## RESPONSE TO REQUEST FOR ADDITIONAL INFORMATION

### APR1400 Design Certification

RAI No.: 25-7844

SRP Section: 06.02.02 - Containment Heat Removal Systems

Figure 1 Sparger Locations within the IRWST

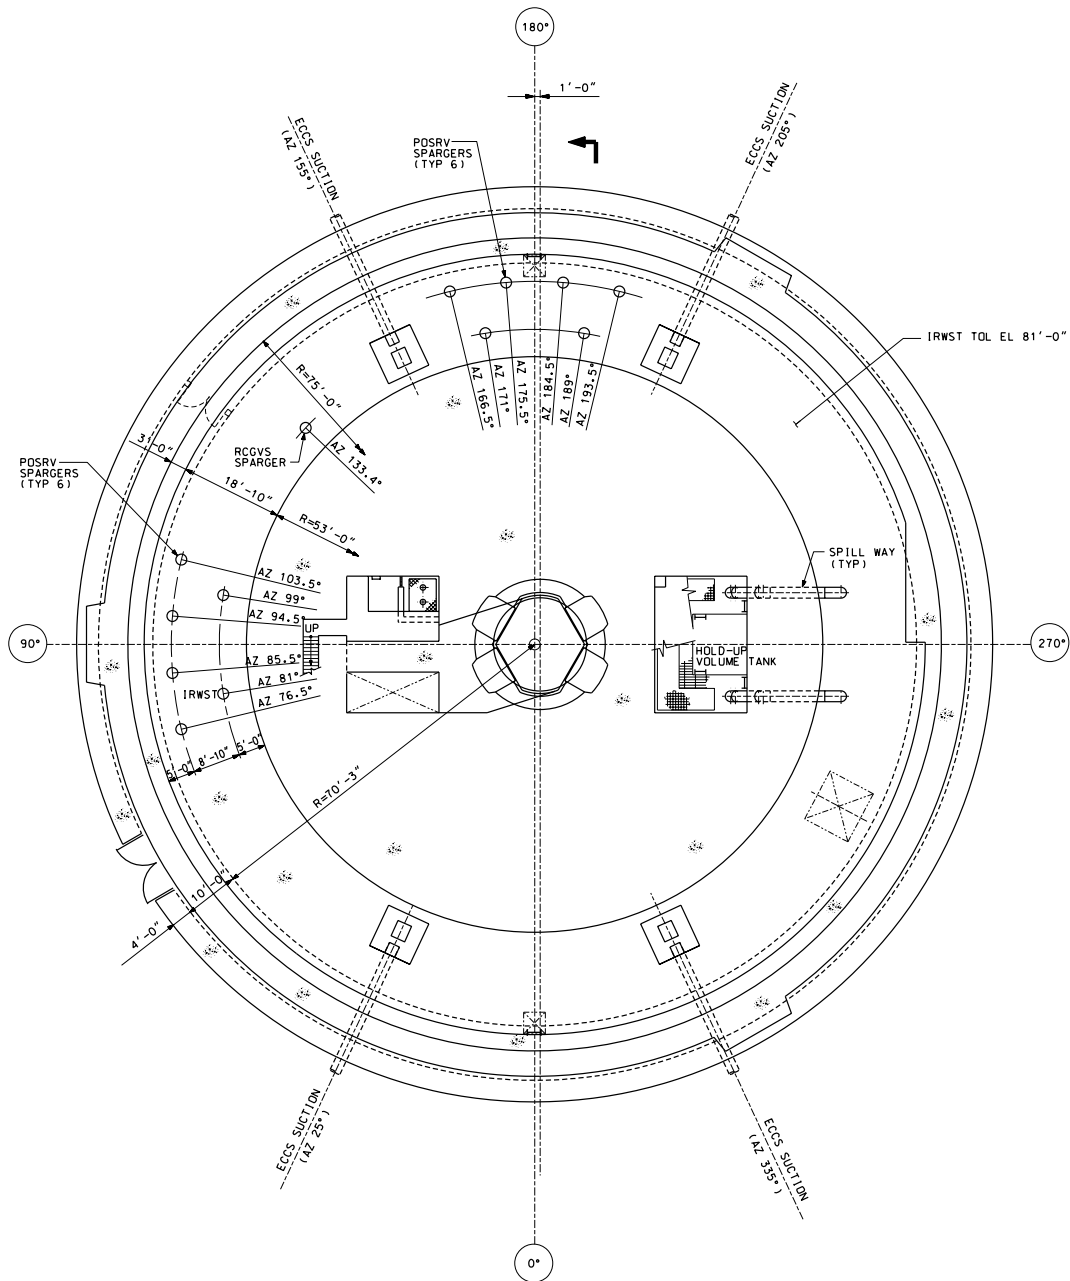
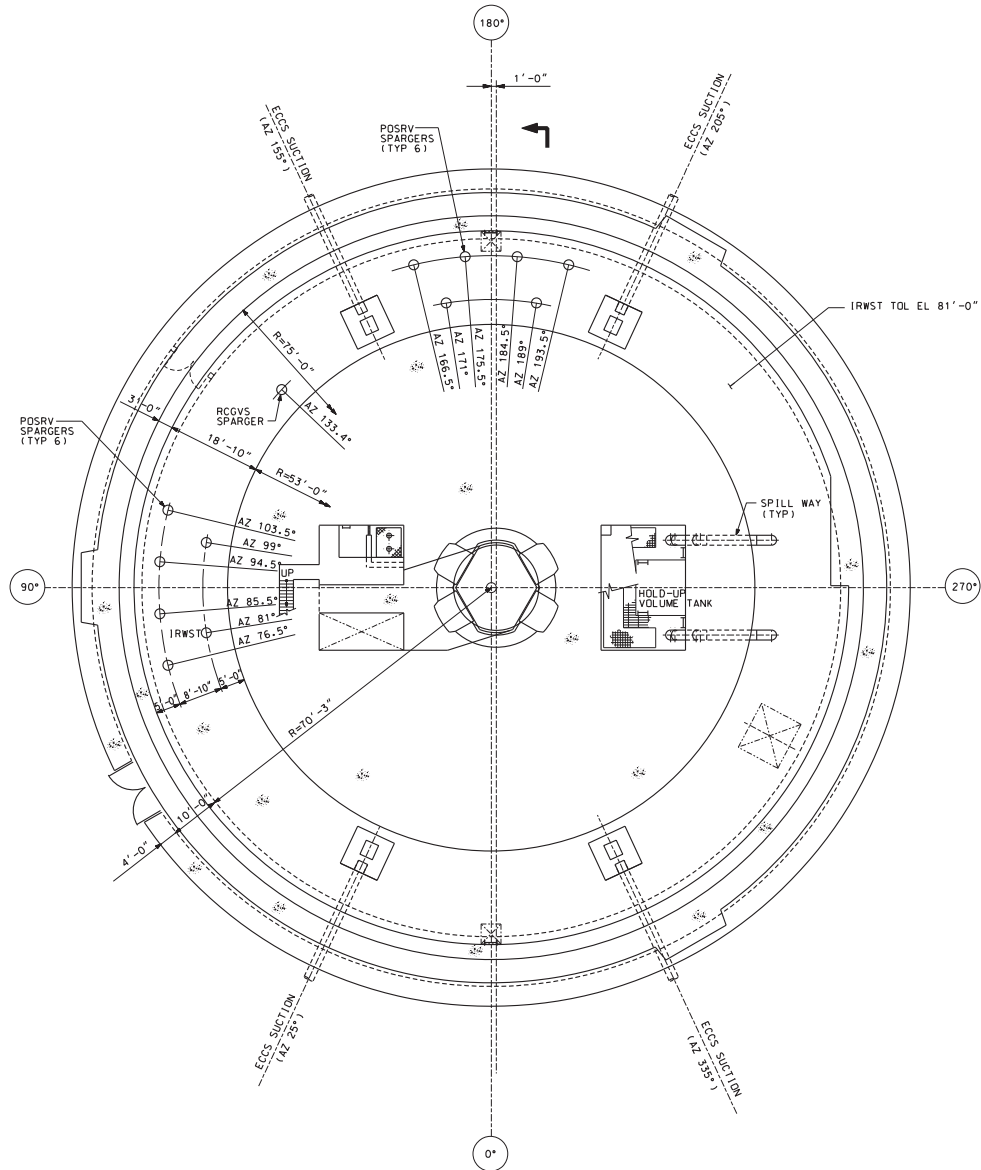
- A. The spargers do not appear in any of the line diagrams in relation to the rest of the IRWST. Update the design control document (DCD) to include the spargers and associated piping within the IRWST, particularly with respect to their elevation and spatial relationship to the strainers. The staff needs this information in order to have a full understanding of the system to make a safety finding that the system will function under all postulated accident conditions.

To identify the spatial relationship of the spargers to the strainers located on the IRWST sump, sparger locations in the IRWST are provided in Figure 1. The IRWST and HVT plan view in DCD Figure 6.8-1 will be replaced with Figure 1, as shown in Attachment 3, to show the RCGVS and POSRV spargers.

Figure 2. Typical header piping and spargers in IRWST

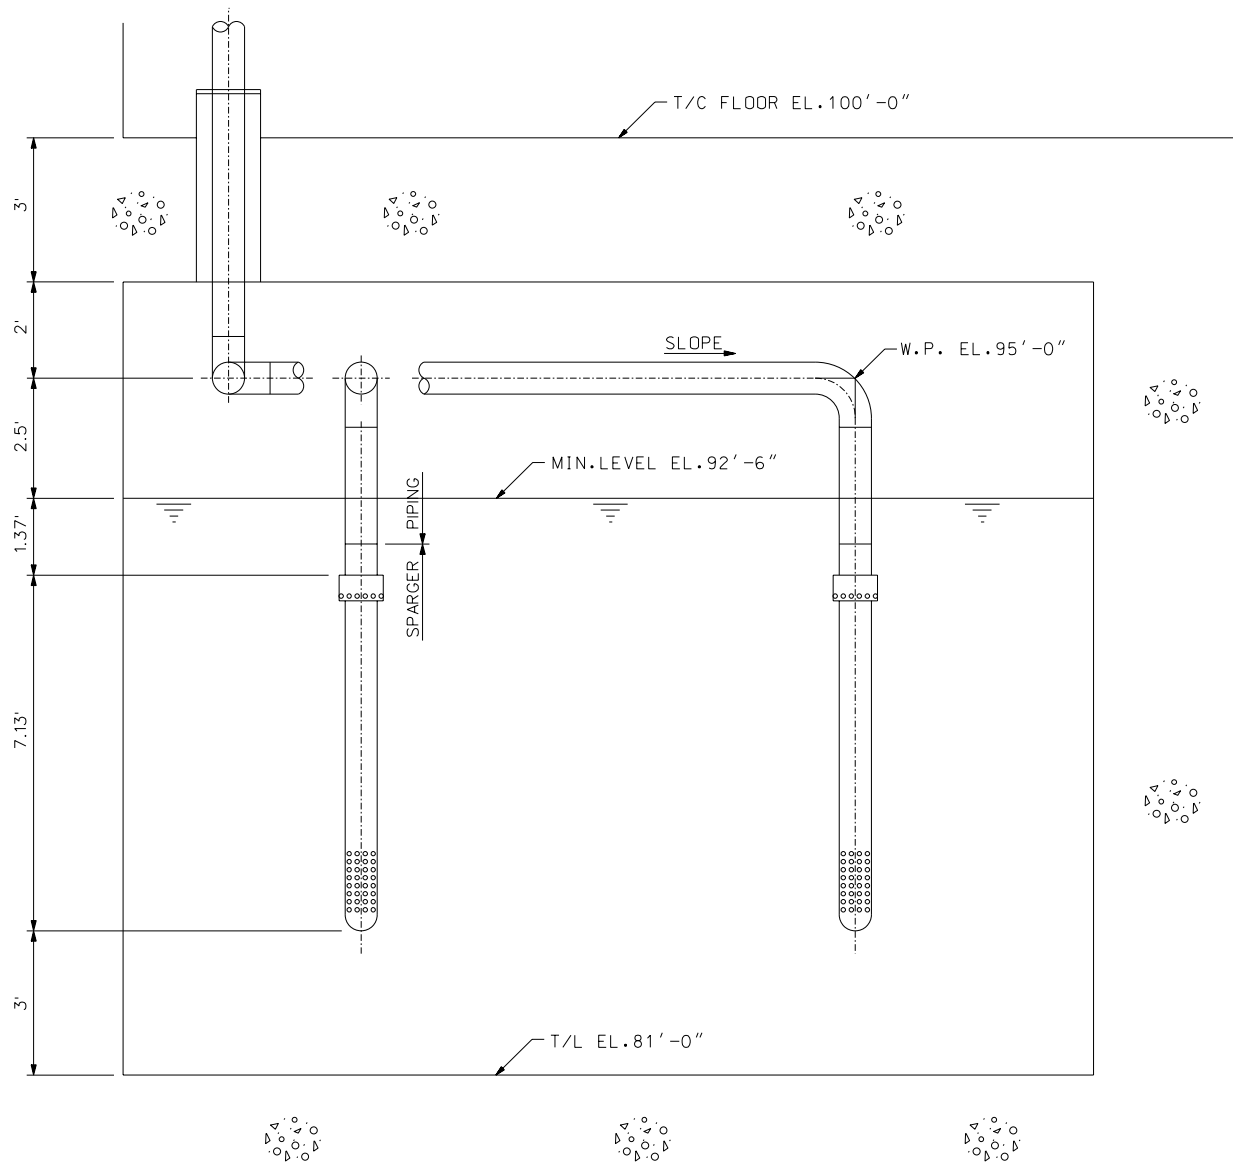
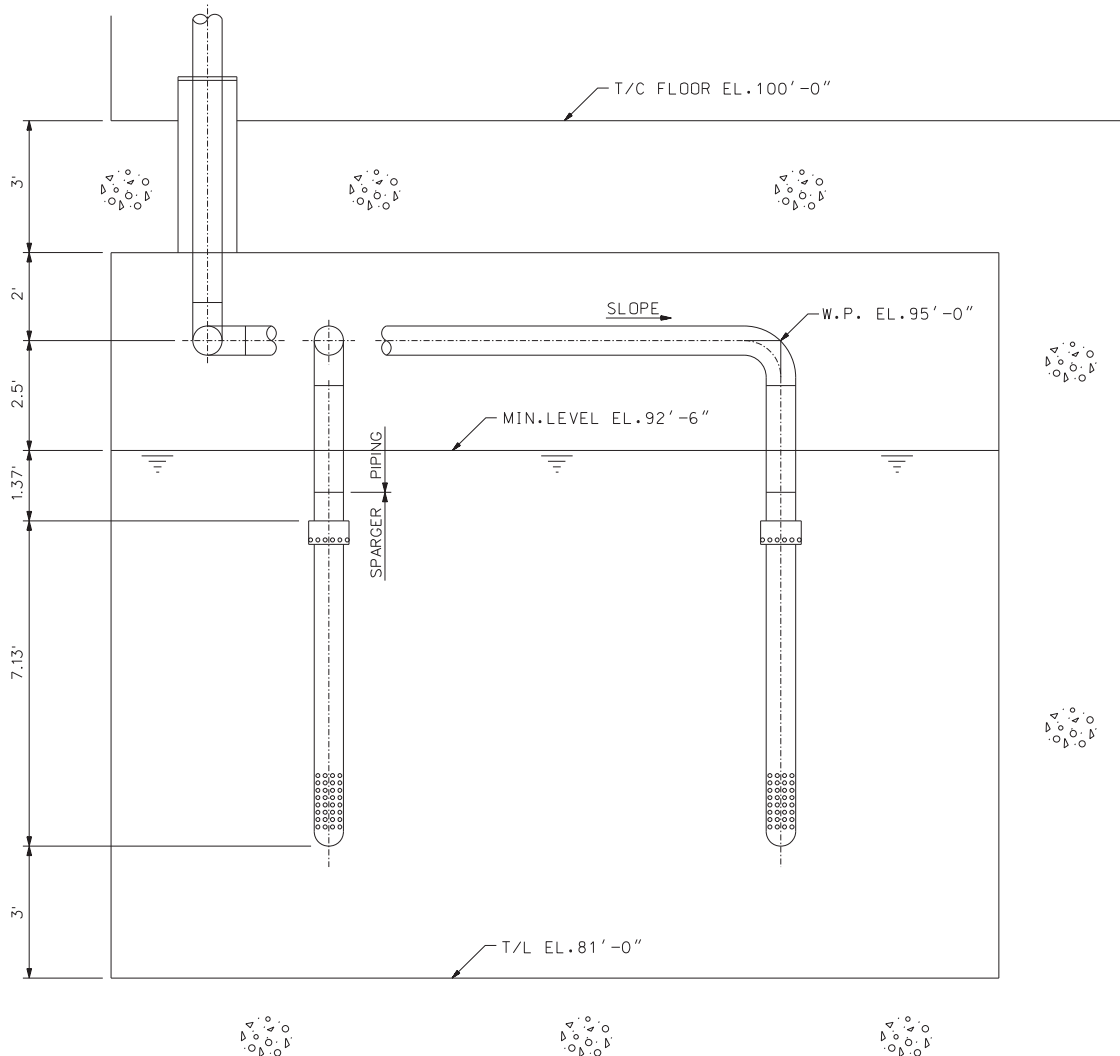
- B. The effect of steam release from the spargers while submerged is discussed in the DCD; however, the effect of fluid release from the spargers while not fully submerged is not explored. Are there any postulated accidents (for example, involving feed and bleed or release from the reactor head vent) where the spargers are uncovered or partially uncovered during release? If so, discuss and explain in detail in the DCD the effects of uncovered release from the spargers on the spargers themselves, the IRWST, and associated structures.

The typical arrangement of header piping and spargers in the IRWST is provided in Figure 2 and will be included in the DCD as Figure 6.8-7. Proposed Figure 6.8-7, "Typical Header Piping and Sparger in IRWST" is included in this response as Attachment 4.

In the APR1400, there are no postulated accidents that cause the sparger holes to be uncovered above the IRWST pool surface during steam release through the POSRVs. Figure 2 shows that the top most holes of the spargers are submerged 1' 4.4" (1.37') below the minimum water level of the IRWST.

Figure 1. Drop size spectrum for main spray nozzle

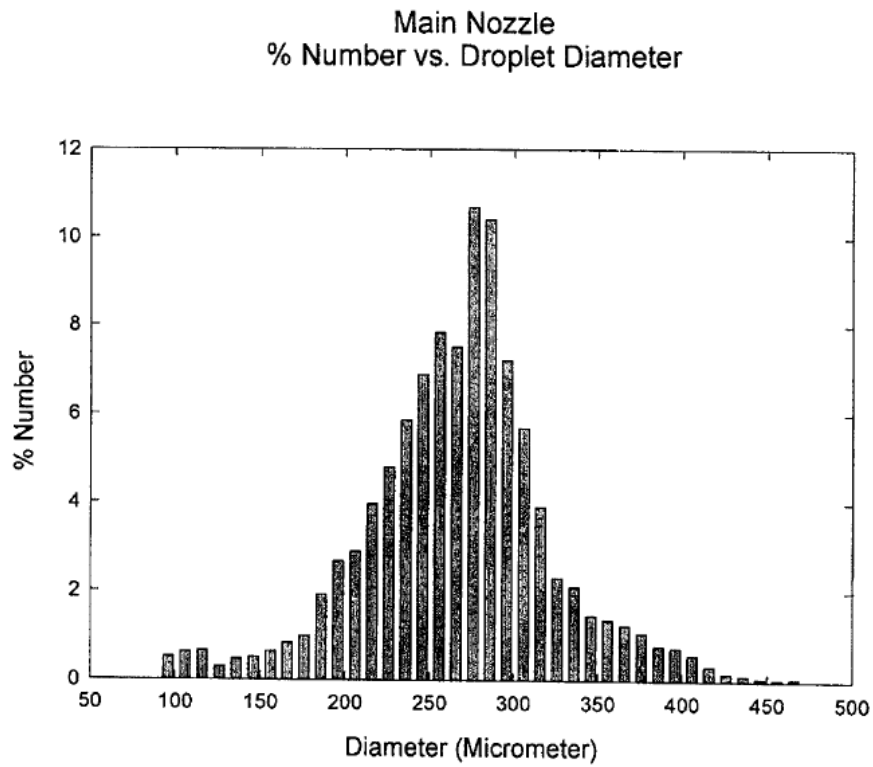
SRP section 6.2.2 stipulates that the spray drop size spectrum as a function of pressure be provided in order to provide the staff reasonable assurance that the test program for the spray nozzles shows the droplets to reasonably be bounded by the values specified in the DCD. Although a mean droplet size as a function of pressure and a maximum droplet size to be used in analyses is specified, no such spectrum of drop sizes is identified. Provide, in the DCD, the range of droplet sizes produced by the spray nozzles.

The drop size spectrums for the main spray nozzles and auxiliary spray nozzles produced at the nozzle design condition of 2.81 kg/cm<sup>2</sup>D(40 psid) are shown in Figure 1 and 2, respectively. These spectrums were obtained by testing as described in DCD Section 6.2.2.4. The testing was conducted by the SVC Inc. in Korea.

The main spray nozzle drop size ranges from 90 microns to 490 microns, and the auxiliary spray nozzle drop size ranges from 60 microns to 260 microns, at the nozzle design condition of 2.81 kg/cm<sup>2</sup>D (40 psid).

Figure 1. CS heat exchanger Modeling for Containment P/T analysis

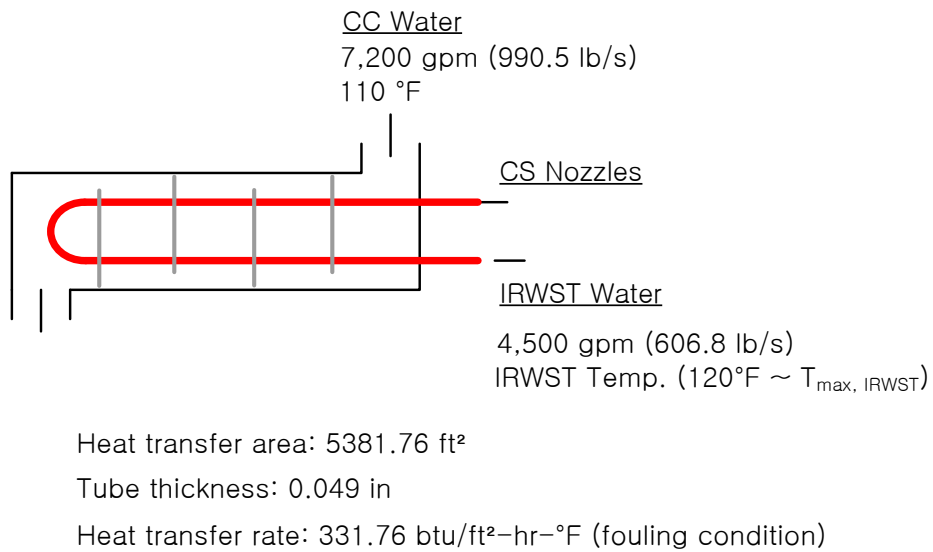
1. SRP section 6.2.2 states that a discussion on the surface fouling used for heat exchangers used to assure containment heat removal capability shall be provided. While the design control document (DCD) references a fouling value for the containment spray (CS) heat exchangers, no such discussion is provided. In the DCD, describe how the value provided in Table 6.2.2-2 is arrived at, including whether the value bounds the fouling values expected over the life of the plant.
2. In a response, describe how the CS heat exchangers are modeled in the analyses presented in Section 6.2 of the DCD. The staff requires this information to complete the following:
  - make a safety finding that the heat exchangers will perform their function over the life of the plant
  - perform a confirmatory analysis

2. The CS heat exchanger used for the APR1400 containment P/T analysis is modeled using a GOTHIC heat exchanger component. The CS heat exchanger model uses a design heat transfer coefficient (UA) and CS heat exchanger input data which are developed from the design specification sheets, summarized in Table 1. Figure 1 shows the schematic diagram of the CS heat exchanger modeled in the GOTHIC containment analysis.
